New Gen III Cool Fuel Module

All MerCruiser sterndrive and inboard engines equipped with Gen III cool fuel systems.

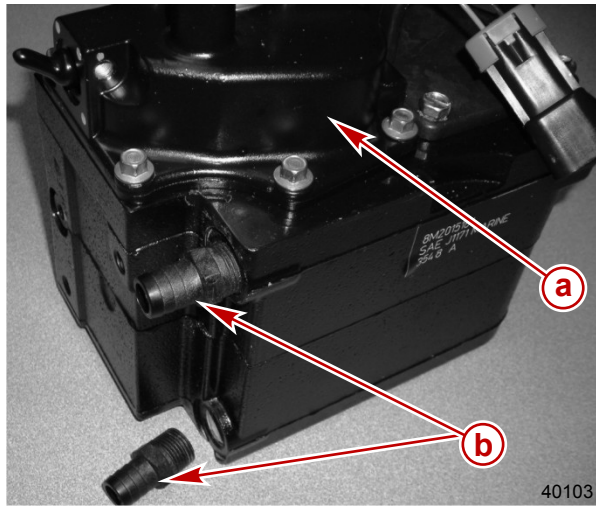
A new Gen III cool fuel module is being introduced to replace the existing Gen III module. Engines with serial numbers above the range listed are equipped with the new module from the factory. The primary difference between the designs is the method of connecting the cooling water hoses to the module. Refer to the Mercury Electronic Parts Catalog (EPC) for replacement modules for engines with serial numbers above the ranges listed.

The new style module will replace any older style module for service needs. In order to use the new module on earlier applications, the cooling water hoses and various fittings must be replaced. Kits are available to accommodate the various possible hose configurations. Order the Gen III Cool Fuel Module with pumps and filter, or a lower module housing only along with the proper hose kit for installation. One module and one kit are required per engine.

Replacement kits	
Complete Gen III module with pumps and filter	864650A13
Lower Gen III module housing (no pumps or filter)	864650A14
Two bib hose kit	865317T02
Three bib hose kit	865208T02

- a** - Gen III cool fuel module
- b** - Barbed hose fitting

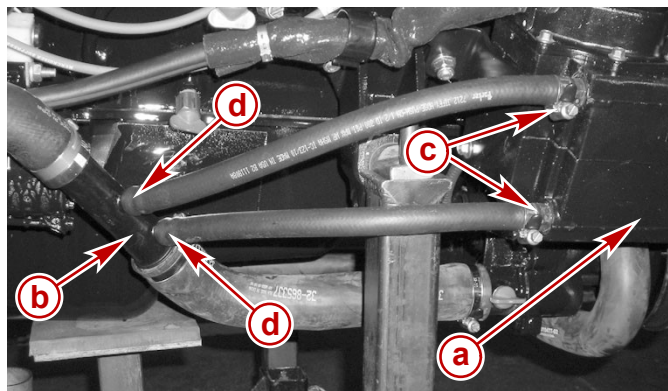
Threaded hose barb fittings are supplied with the new Gen III cool fuel module. The threads on the barbed hose fittings and the threaded bore must be coated with Perfect Seal. Any removal of the fitting will require resealing the threads. Refer to the instruction sheet with the module for additional installation information.
